**VICE PRESIDENT FOR RESEARCH**  
THE UNIVERSITY OF UTAH

**Subject: UUTR Technical Specification Amendment Request – Clarification of the Administration Organization for UUTR Operation (License No. R-126, Docket No. 50-407) and - Notification of new Administrator (Level 2)**

# Chapter 14

**TECHNICAL SPECIFICATIONS AND BASES FOR THE UNIVERSITY OF UTAH  
TRIGA NUCLEAR REACTOR**

**Figure 6.1**

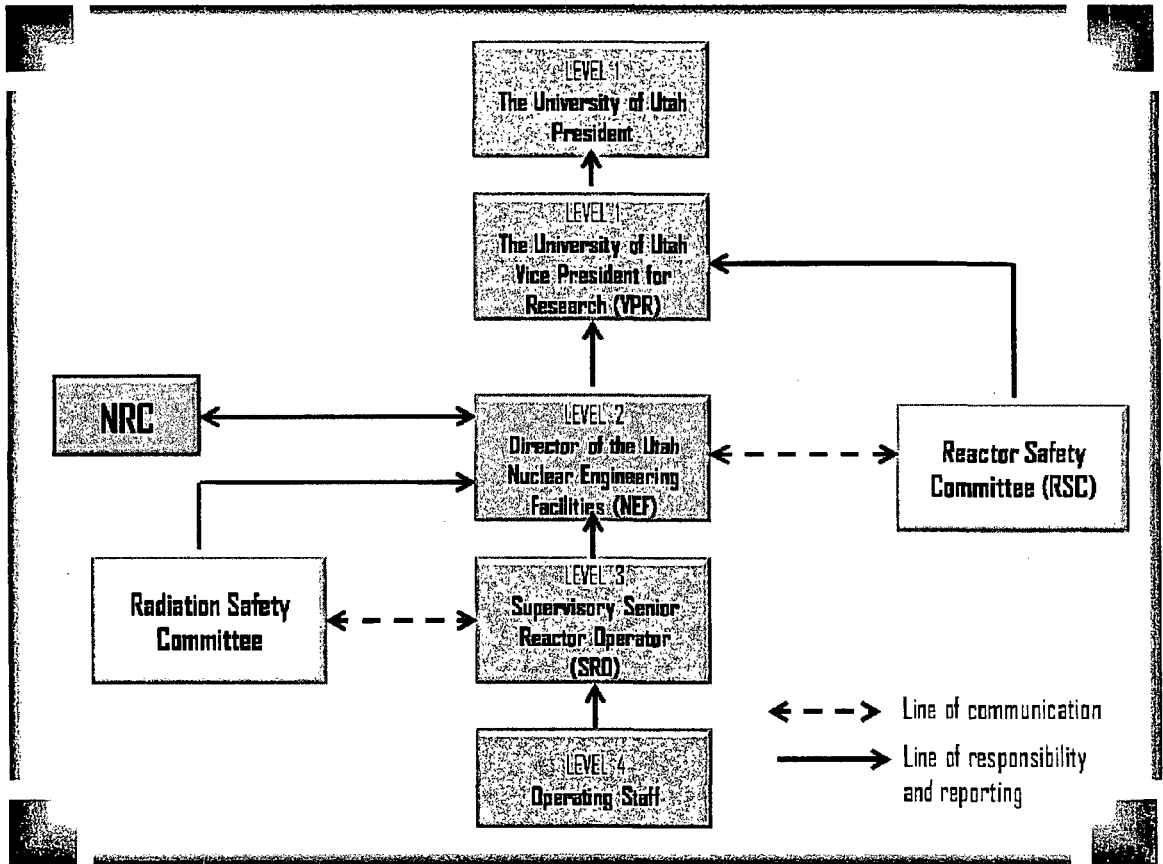
This letter is to provide clarification of the University of Utah 100 kW TRIGA Reactor (License No. R-126, Docket No. 50-407) (UUTR) Administrative Organization chart existent in the Technical Specification ( Chapter 14) submitted together with SAR in 2005. This clarification is submitted as amendment #7, attached. The clarified organization chart is Figure 6.1, in Section 6.0 Administrative Controls, in Chapter 14 Technical Specification, pg.26. In the attached file, Figure 6.1 is redrawn to more clearly show the facility organization and management, lines of communication and lines of responsibility and reporting. This is designed to be in full compliance with the ANSI/ANS 15.1-2007 and ANSI/ANS 15.4-2007 regulations. Section 6.0 Administrative Controls was also rearranged to follow NUREG 1537 Part 1 & 2, and ANSI/ANS 15.1-2007 and ANSI/ANS 15.4-2007 regulations. The clarifications in Section 6.0 do not reflect any substantive changes in our administrative organization.

Note: changes from the TS submitted in 2005 are in CHAPTER 6 [Fig.6.1 is clarified; whole Chapter is rearranged to follow the ANSI/ANS 15.1-2007 and NUREG 1537 Part 1 & 2]

**University of Utah Administrative Organization for Nuclear Reactor Operations [Clarified - December 2009; in compliance with ANSI/ANS 15.1-2007]**
